TV

MANUFACTURERS' RECEIVER TROUBLE CURES

VOLUME 7

Fig. 4 — Hoffman

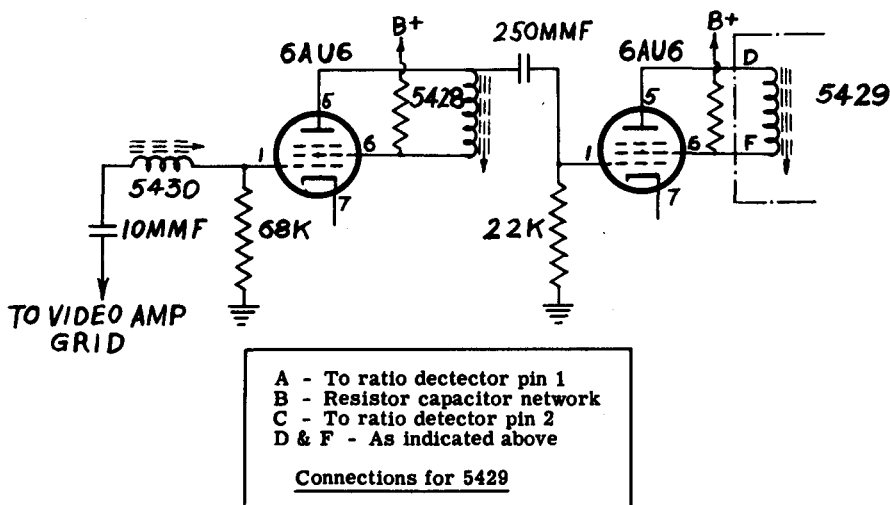
Preventing excessive loading on horizontal output transformer.

R719, the 100k-ohm, 1-watt resistor that is shunted across lugs 1

and 2 of L703 (horizontal yoke winding) is deleted from the above chassis. The change results in a slight increase in high voltage and horizontal width. It is suggested that the change be made on service call as preventative maintenance since should R719 decrease appreciably in value over a period of time, the result would be excessive loading on the horizontal output transformer, causing low horizontal sweep, low high voltage, and low agc keyer pulse. In some instances, the lowering in keyer pulse has been responsible for sync clipping because the agc bias became too low in a strong signal area.

Fig. 5 — Hoffman

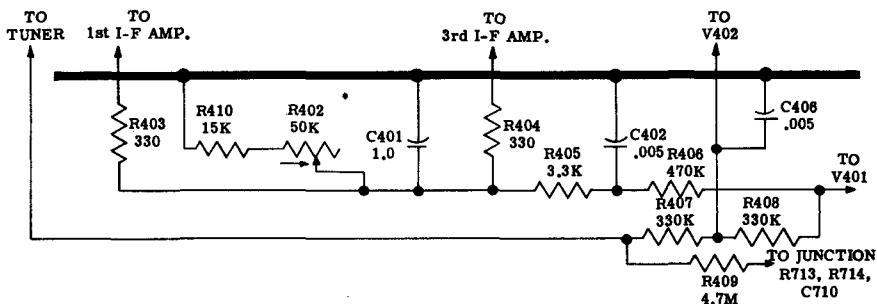
above series receivers. The new control is located on the chassis rear apron next to the Horizontal Frequency knob. The figure shows the new agc circuit. A comparison of this circuit with the original schematic diagram will disclose that R402, the 47k-ohm resistor that forms a portion of the agc voltage divider, has been replaced by a 50k-ohm potentiometer connected as a rheostat and a 15k-ohm fixed resistor. This circuit arrangement places the position of the tap on the i-f agc voltage divider at the discretion of the serviceman. In order to maintain the crossover point of the r-f and i-f agc voltage where it was prior to the above change, it is necessary to increase R407, the 180k-ohm resistor, to 330k ohms in the delayed agc network.

When the agc control is turned fully clockwise, the greatest bias appears on the i-f agc bus and the lowest

bias appears on the r-f agc bus for a given signal. When the control is turned fully counterclockwise, the situation is reversed; the i-f agc bias voltage is minimum and the r-f agc bias is maximum for a given signal. This source of high r-f bias is very useful when strong signals cause the video stages to overload, clipping the sync pulses.

Fig. 6 — Hoffman

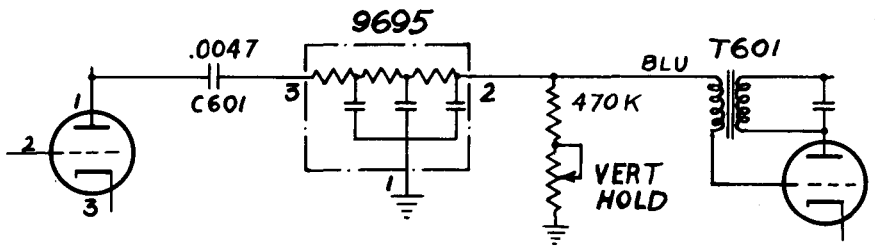
Picture shift at maximum contrast.

Some of the receivers listed above have had a slight horizontal shift when maximum contrast was used. This condition can be remedied by increasing the value of R304, 47-ohm, 1/2-watt, 20% resistor (connected between the low side of the contrast control and ground) to a 150-ohm, 1/2-watt, 20% resistor. When this is done, a connection should be run from the top, *not ground*, of this 150-ohm resistor to the Fringe position of the Maximum Performing selector switch on the rear of the set, so that when in a Fringe position, maximum contrast can still be obtained.

Fig. 8 — Hoffman

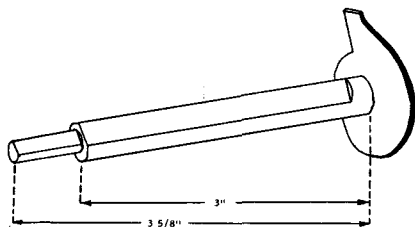
HOFFMAN Chassis with
tuners 9684, 9716,
9717 and 99532
Cascode tuner adaptation
(see Fig. 8).

The following information is intended for use with tuner 9788 (Standard Coil 20-mc cascode) when use as replacement for the above tuners. The shaft length must first be modified to match the length of the old tuner. To modify the shaft length, remove the screw that holds the fine tuner in place and remove fine tuning shaft. Cut fine tuning shaft to 3-inch length measured from front of dielectric wafer. Replace fine tuning shaft and cut off main shaft to $3\frac{5}{8}$ -inch length measured from front of dielectric wafer. Main shaft should be $\frac{5}{8}$ -inch longer than the fine tuning shaft when modification is completed. Be sure no metal filings are left between the fine tuning shaft and main tuner shaft.

The 9788 and 9717 tuners are directly interchangeable both mechanically and electrically. One electrical change is required to substitute 9788 for 99532 (Silver Circle), 9684, and 9716. Connect red lead, black lead and white lead as indicated above. Connect blue lead to 275 volts (dc) through 1k-ohm, 1/2-watt resistor. Connect a .005- μ f capacitor from blue lead to ground.

Fig. 9 — Magnavox

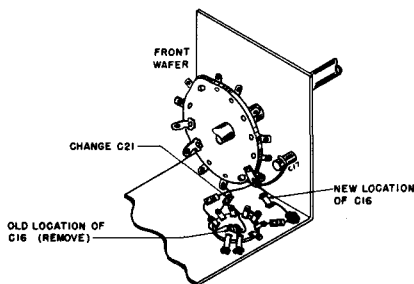
MAGNAVOX Chassis 103-series
Correcting sound drift
 (see Fig. 9).

1. Replace *C21*, 10- μ mf capacitor (black, brown, black, black, white) with 10- μ mf, N750 capacitor (violet, brown, black, black, white), part No. 250088G63. *C21* is the capacitor connected to the front lug at the base of the front wafer.

2. Remove *C16*, 3- μ mf N750 capacitor (violet, black, orange, black) from oscillator socket.

3. Add 3- μ mf, N1800 capacitor (orange, orange, black, orange, black, green), part No. 250088G57, from rear lug at bottom of front wafer (connection point for *C17* oscillator trimmer) to chassis ground in front of oscillator socket (connection point for *C22*). Keep leads as short as possible.

Although the above changes should correct this difficulty, in persistent cases change *C18*, 100- μ mf capacitor to part No. 250088-13, 100- μ mf, N750 unit. It is also advisable to check the 22,000-ohm oscillator grid resistor *R9*, as this will sometimes change value with temperature increases. Changing *C18* and *R9* may also help in curing a similar complaint on the horizontally mounted chassis, but *C16* and *C21* should not be changed in this case.

Fig. 10 — Magnavox

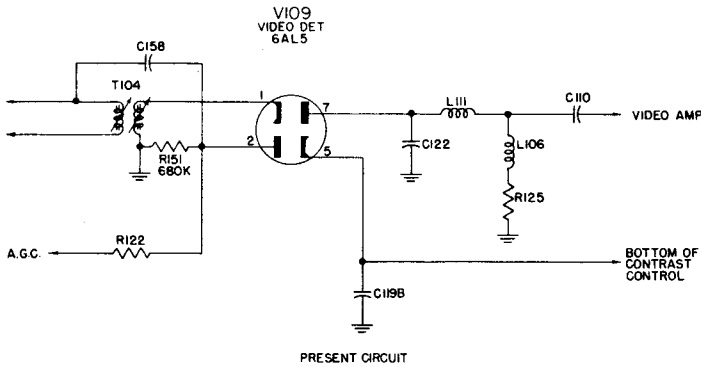
MAGNAVOX Chassis 104-series
Removing adjacent channel interference.

To remove adjacent channel interference where necessary, install trap No. 360457-1 from 1st i-f plate to ground and tune to 27.25 mc.

For rejection of a 19.75-mc signal, connect trap to the plate of the 2nd i-f amplifier.

Fig. 11 — Magnavox

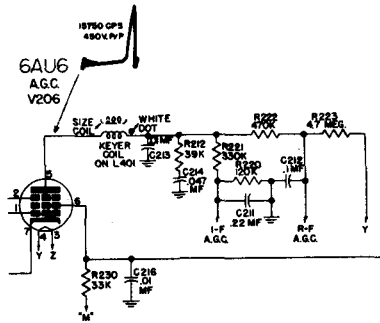
8. If agc is being developed but not in proper relationship, check the biasing network. This can be checked by unsoldering one end of *R223* (see figure); each resistor can then be measured separately. Check *C211*, *C212* and *C214* for open or short.

Fig. 12 — Magnavox

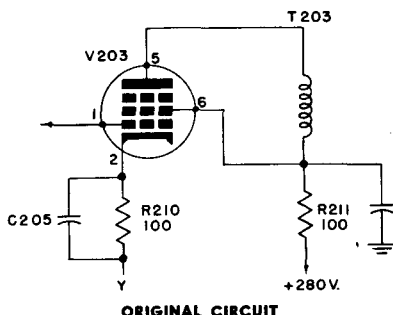
This control can be installed in place of color converter jack.

Adjust noise bias control for most stable sync.

Fig. 13 — Magnavox

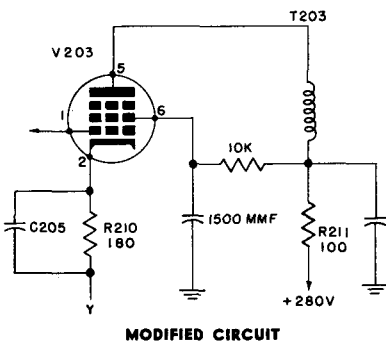
If signal blocks when tuning from weak to strong signals, proceed as follows:

3. Blocking may be due to excessive grid current in V_{203} , the 3rd video i-f amplifier. This circuit may be modified as shown in the illustration.

Fig. 14 — Magnavox

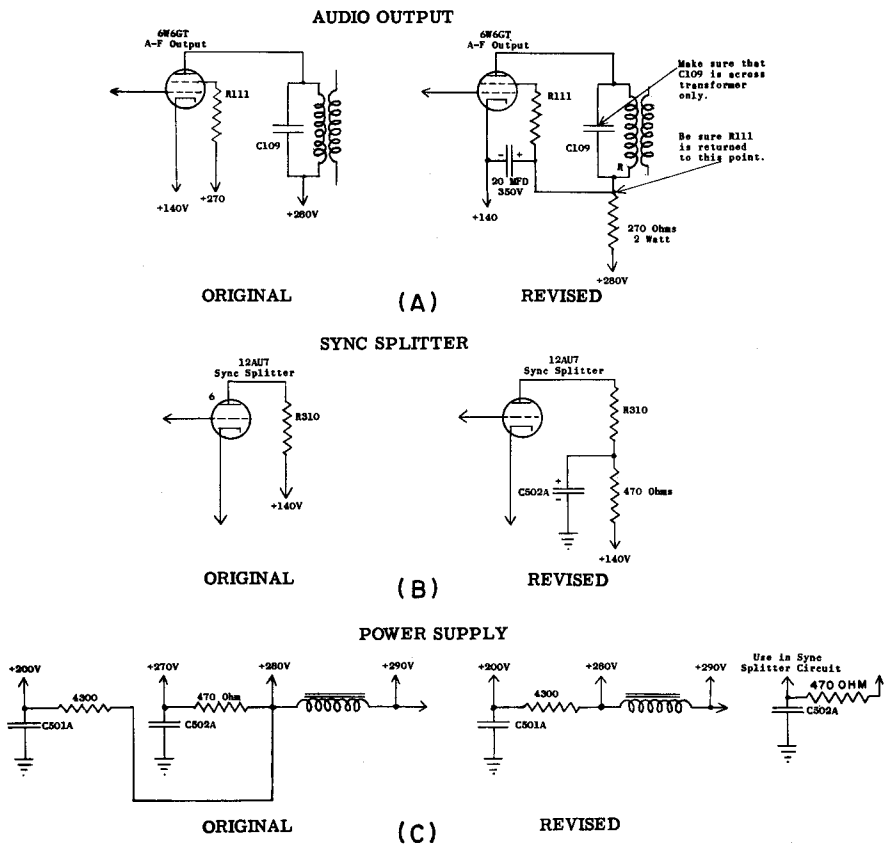
MAGNAVOX Chassis 108-series Reducing hum and buzz (see Fig. 14).

The schematic diagrams shown here illustrate the circuit revisions used for reducing hum and buzz in the above series chassis when necessary. Notes on the schematic diagrams indicate important points to check when making these changes to insure proper operation.

The changes involve the addition of decoupling filters in the audio output and sync splitter stages. Note that the components required for the sync splitter may be obtained from the power supply circuit.

Fig. 16 — Majestic

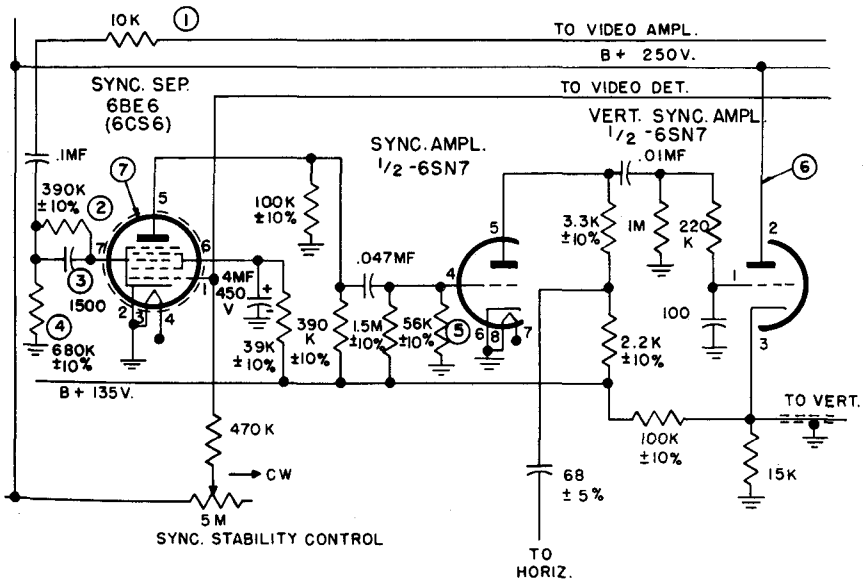
The following changes, already made in later production of the above chassis (coded with suffix letter *A* following chassis series code) are incorporated in order to provide improved sync stability. These changes also allow the Sync Stability control to be further advanced for noise immunity in high signal areas.

1. Add 10k-ohm, $\pm 20\%$, $\frac{1}{2}$ -watt resistor in series with sync input lead.

2. Add 390k-ohm, $\pm 10\%$, $\frac{1}{2}$ -watt resistor in series with sync separator control grid.

3. Add 1,500 μmf , $\pm 20\%$, ceramic capacitor in series with sync separator control grid.

4. Change sync separator grid resistor from 470k ohms to 680k ohms, $\pm 10\%$, $\frac{1}{2}$ watt.

5. Add 56k-ohm, $\pm 10\%$, $\frac{1}{2}$ -watt resistor from pin 4 of sync amplifier 6SN7 to ground.

6. Remove 33k-ohm plate resistor of vertical sync amplifier and connect plate (pin 2) to 250-volt B+ instead of 135-volt B+.

The schematic diagram shows the revised sync amplifier circuits, with the circled numbers corresponding with the numbered steps above.

Fig. 17 — Mars

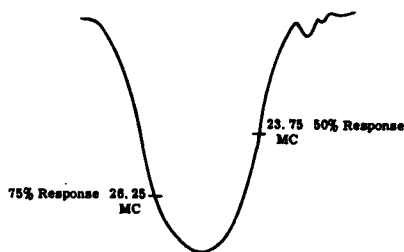
MARS TV Model 630-K3B
Extreme fringe area alignment
(see Fig. 17).

For extremely difficult fringe area coverage where signal-to-noise ratio is a problem, it is possible to narrow the 4-mc i-f bandwidth to 2 1/2 mc to obtain extra gain and a better signal-to-noise ratio. It has been found that in the nominal 100 to 150 mile sector where video reception is possible but not comfortably viewable, the 2 1/2-mc bandwidth will in most cases bring in the picture to a suitable viewable point, minimizing snow.

Make sure to readjust all the traps to their proper frequencies (as listed on the schematic circuit diagram) before and after spot alignment. Then remove the signal generator and con-

nect a sweep generator to the antenna input at any one of the low frequency channels and touch up the i-f coils for the response indicated in the illustration, making sure that the 26.25-mc point and the 23.75-mc point are adjusted as indicated on the curve. Should any of the i-f's require more than a touch-up, the trap associated with that stage must be retuned. It is usually a good procedure to recheck all the traps after sweep alignment.

Fig. 19 — Motorola

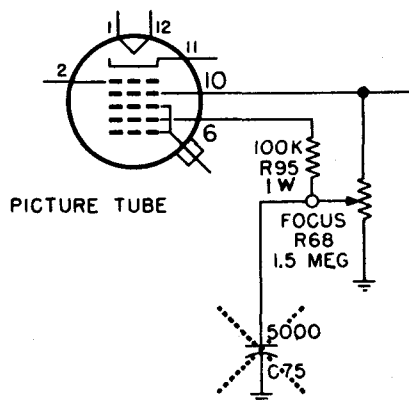
Providing added protection to focus control (see Fig. 19).

To add protection to the focus control potentiometer, the following changes, already made in later production are included:

1. C75, 5,000- μ mf capacitor is removed.
2. R95, a 100k-ohm, 1-watt resistor, is added between the focus control arm and the blue lead to the picture tube focus anode. (Note: The

Fig. 22 — Motorola

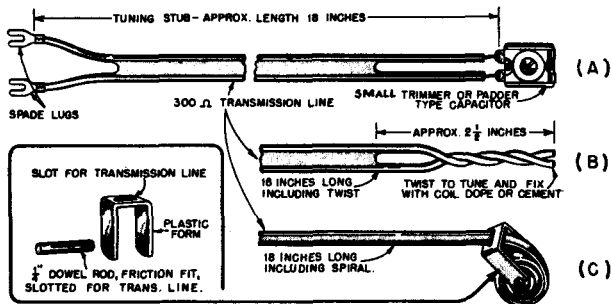
Television interference from 2-meter amateur transmitters may occur on channel 10, especially in older model tv sets. The method usually used to improve tv reception in this case, is to use a quarter-wave open-end stub at the antenna terminals of the tv set.

Since the cut-and-try method of obtaining the correct length of the stub is not too effective in actual practice, a means of tuning the open-end quarter-wave stub is the logical answer to the problem. The sketches il-

illustrate these methods of accurately tuning the stubs for optimum performance.

Fig. 32 — Packard-Bell

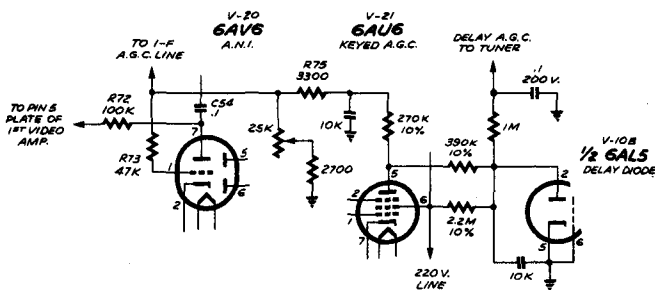
PACKARD-BELL Chassis 2740
Addition of delayed agec
(see Fig. 32).

The addition of delayed agc circuitry is incorporated in later production of the above chassis. Improved performance will be noted in fringe areas, as evidenced by an increase in signal-to-noise ratio due to the r-f amplifier bias being held near zero for low signal input. High signal areas will benefit because of the much greater input signal now required to produce overload or cross modulation effects. Chassis incorporating this delay circuit can be identified by the agc control located on the chassis rear apron near the horizontal drive control.

CIRCUIT CHANGES, D-201 CHASSIS, FOR INCREASED LIFE OF 12B4 TUBE

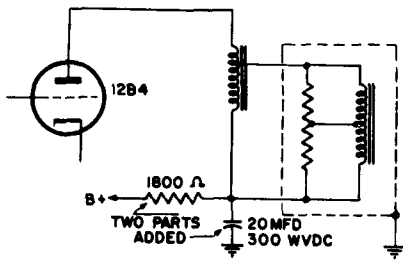
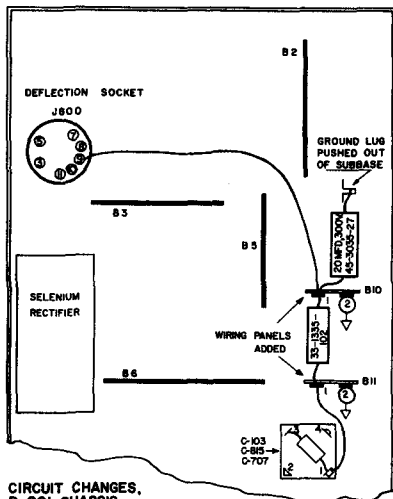
1. Mount two 2-lug wiring panels in the locations shown on the accompanying layout drawing. These panels will be referred to as *B10* and *B11*.

Fig. 34 — Philco

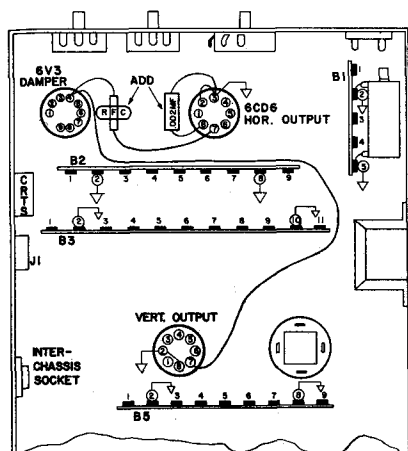
1. Add a .002- μ f, 400-volt capacitor (part No. 30-1238-8 or 30-4650-

37) between pin 3 and pin 8 of the 6CD6G horizontal output tube. Schematically this capacitor is added from screen grid to cathode of the 6CD6G tube.

Fig. 37 — Philco

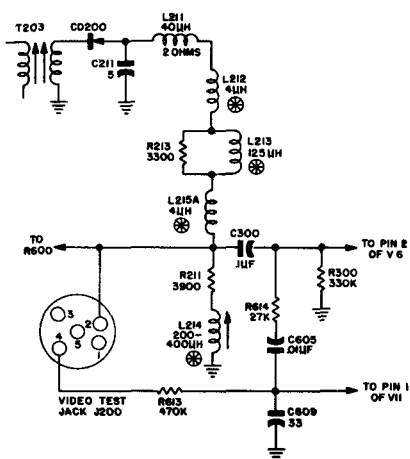
To reduce channel 5 picture beat, an additional 4- μ h series peak-

ing coil (*L215A*, part No. 324112-50) is added to the video detector load circuit. To install this coil, terminal board *B9* adjacent to the video test jack is changed from a 2-lug to a 3-lug type. The revised wiring of the video detector circuit, already done in later production run 18, is shown in the figure.

Fig. 38 — Philco

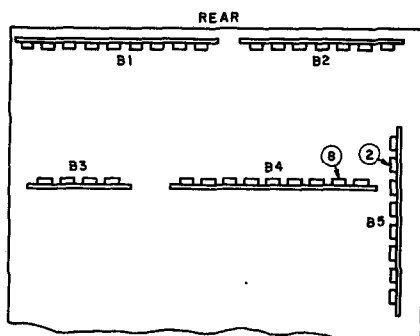
PHILCO R-f chassis R-191
Improving video transient response (see Fig. 38).

To improve video transient response, all wiring is interchanged between lug 8 of terminal board *B4* and lug 2 of terminal board *B5*. A bottom view of the chassis showing these

boards is shown in the figure. This change is already made in later production run 3.

Fig. 39 — Philco

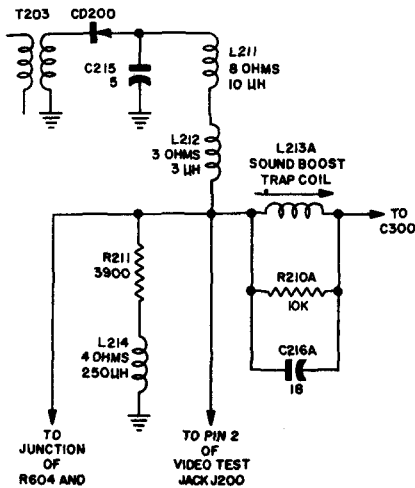
1. *L213* and *R210* are replaced by a 4.5-mc sound boost trap coil in the

video detector circuit (new part No. 32-4463-7).

Fig. 41 — Philco

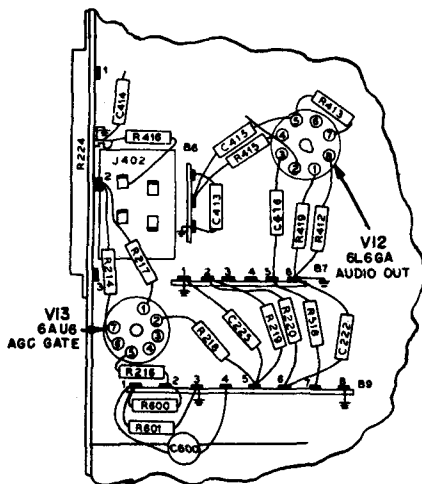
To permit use of the uhf tuner with the above chassis, the following changes, already included in later production are made:

1. Lead of resistor *R518*, 15k ohms, is moved from lug 5 to lug 4 of terminal board *B7*.

Fig. 42 — Radio Craftsmen

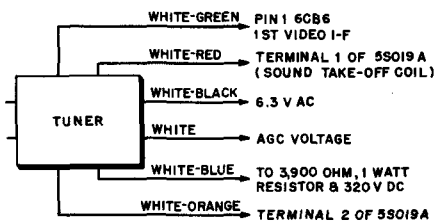
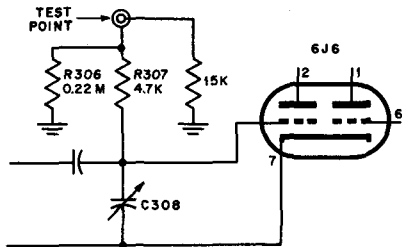
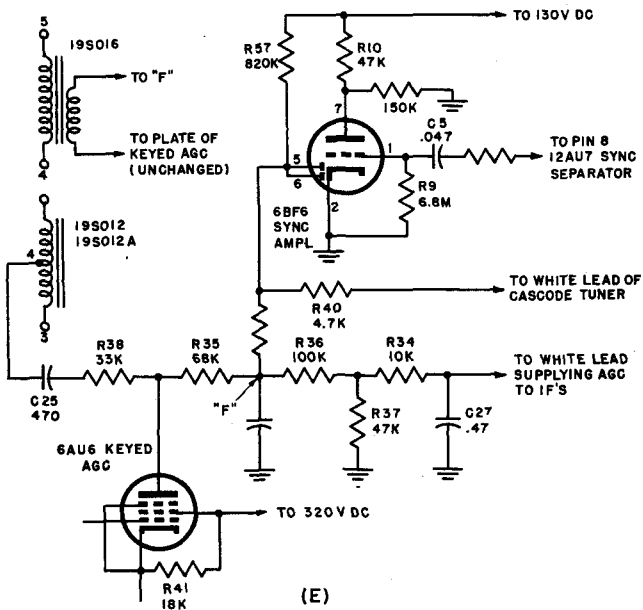
How to Install the Sound Take-off

Mount the sound take-off coil (part No. 5S019A) directly behind the cascode tuner. Use the elongated hole (see part C of the figure) as a guide in locating two 5/32-inch mounting holes. Drill the holes. Enlarge the elongated hole with a 5/16-inch drill to provide a hole for tuning the coil later. Mount the coil in the position indicated in part (D) of the figure.
